Access Compliance Report

Public Rights-of-Way

(Curb Ramps)

Intersection ID: 10022624	Main Street: CARMEL_RD	Cross Street: N/A	Location: W
ADA ID: 249F85D96380	Ramp Type: PerpDiag	Initial Pass/Fail: Fail	Overall Compliance: No
Severity Score: 21.25			
Codes/Mitigation Info/Possible Solution		Field Measurements/Component Compliance

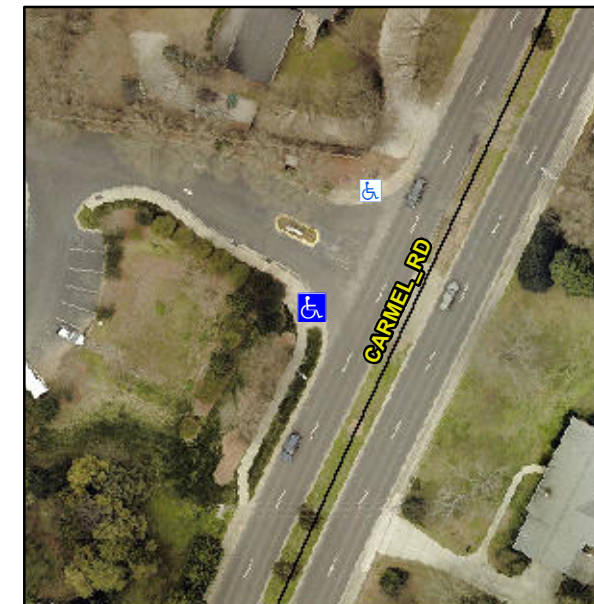
Not Found, R304.5.1, R304.2.2

Compliance	Description	Data	Compliance	Description	Data
N/A	Ramp Length (in)	97.0	No	Ramp Slope (%)	9.1
No	Ramp Width (in)	44.5	Yes	Ramp XSlope (%)	0.7
N/A	Flare Type LT	N/A	N/A	Flare Type RT	N/A
N/A	Flare Slope LT (%)	N/A	N/A	Flare Slope RT (%)	N/A
N/A	Flare Traversable LT?	N/A	N/A	Flare Traversable RT?	N/A
N/A	Landing Length (in)	N/A	N/A	DWS Provided?	N/A
N/A	Landing Width (in)	N/A	N/A	DWS Contrast?	N/A
N/A	Landing Slope (%)	N/A	N/A	DWS Length (in)	N/A
N/A	Landing X Slope (%)	N/A	N/A	DWS Full Width?	N/A
N/A	Landing Curb? (Y/N)	N/A	N/A	DWS Offset (in)	N/A
N/A	Shared Landing?	N/A			
N/A	Gutter Ponding?	N/A	N/A	Gutter Slope (%)	N/A
N/A	Gutter Lip Ht (in)	N/A	N/A	Gutter X Slope (%)	N/A
N/A	Painted X Walk1?	No	N/A	Painted X Walk2?	No
	X Walk 1 Direction	To SE		X Walk 2 Direction	To NE
N/A	X Walk 1 Width (in)	N/A	N/A	X Walk 2 Width (in)	N/A
	X Walk 1 Slope (%)	2.5		X Walk 2 Slope (%)	1.5
	X Walk 1 X Slope (%)	0.6		X Walk 2 X Slope (%)	1.2

Remove & Replace Curb Ramp With Two New Directional Ramps or Equivalent.
